AIR - HP/LP TURBINE ACC SYSTEM - VALVE VANE REPLACEMENT AND ADDITION OF PLUG STORAGE
PLATE TO HPT/LPT ACC AIR VALVE - CATEGORY CODE 4 - MOD.ENG-75-0021

V2500-ENG-75-0021

AIR - V2500 - HPT/LPT ACC AIR VALVE ASSEMBLY, PART NUMBERS 5860016-107 THROUGH 5860016-113 and 5860016-117. UPGRADE TO 5860016-119/-120 AND 5860016-121/-122.

Family Tree - HPT/LPT ACC Air Valve Ref. Catalog Sequence No.75-24-51, Fig 01, Item 100
Fig.1

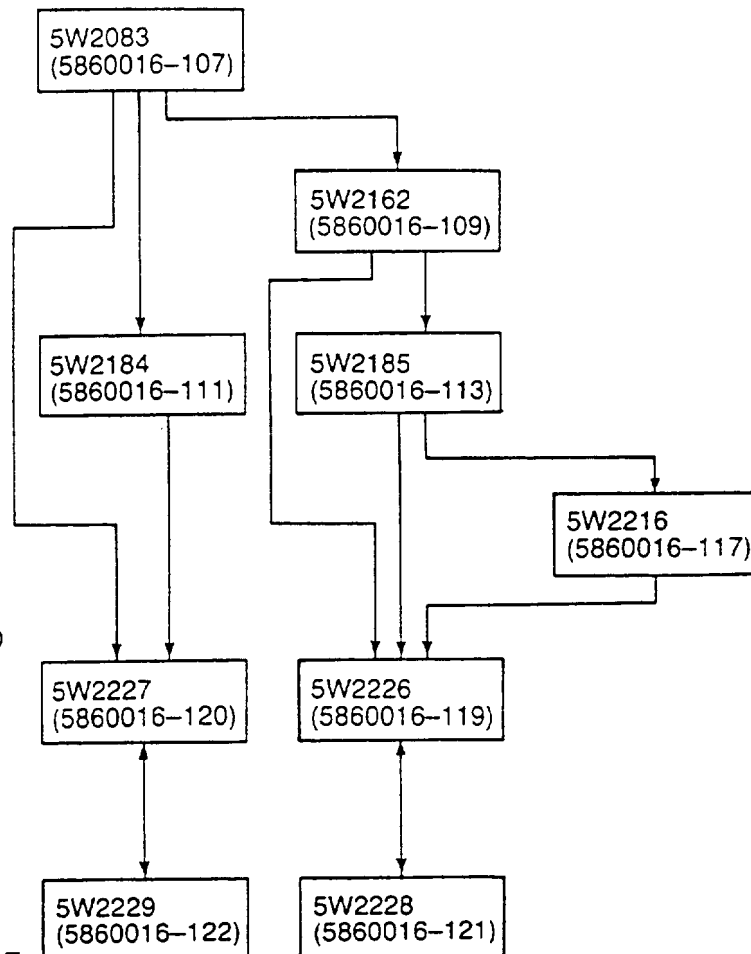
V2500-ENG-70-0050
RIB ADDED TO THE
CAMBOXV2500-ENG-75-0012
SEAL RINGS REMOVEDV2500-ENG-75-0018
CONTROLLED SERVICE
USE: 4-HOLES AND
SINGLE SEAL RING
ADDED: PLUGS REMOVEDV2500-ENG-75-0021
PART 1, 3
4-HOLES, SINGLE SEAL
RING AND PLUG
STORAGE PLATE ADDED:
PLUGS ON HPT VALVE
VANEV2500-ENG-75-0021
PART 2
PLUGS ON PLUG STORAGE
PLATE

External Plug Storage Plate Reference
Figure 1

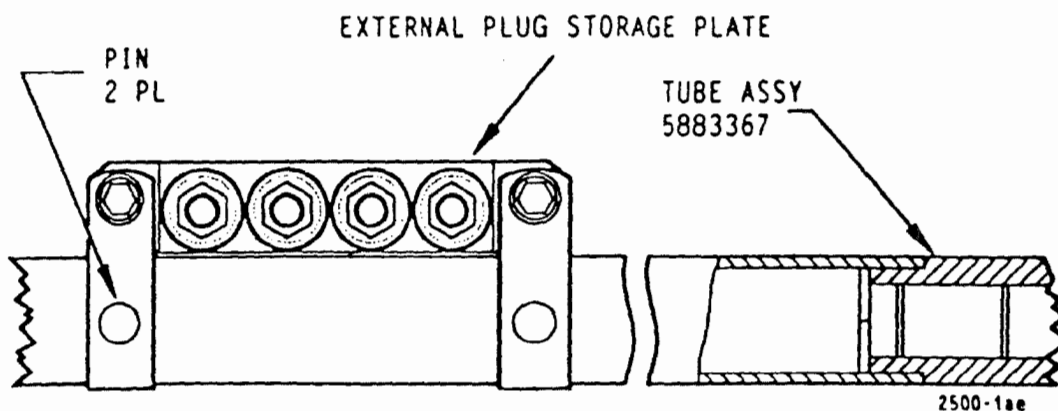
CAUTION: BEFORE BEGINNING OPTION 2 IN THIS SERVICE BULLETIN, OPERATORS ARE ADVISED TO REFER TO FIGURE 1 IN THIS SERVICE BULLETIN AND CHECK THEIR VALVE AS NOTED.

NOTE: The external plug storage plate is used to visually identify the specific location of the HPT vane plugs. Check and verify that either of the following is applicable:

1. If the vane plugs are contained in the external plug storage plate, it shall be concluded that they are no longer in the valve HPT vane.
2. If the vane plugs are not visibly contained in the external plug storage plate and the four holes are visibly empty, it shall be concluded that the HPT vane contains the four vane plugs.
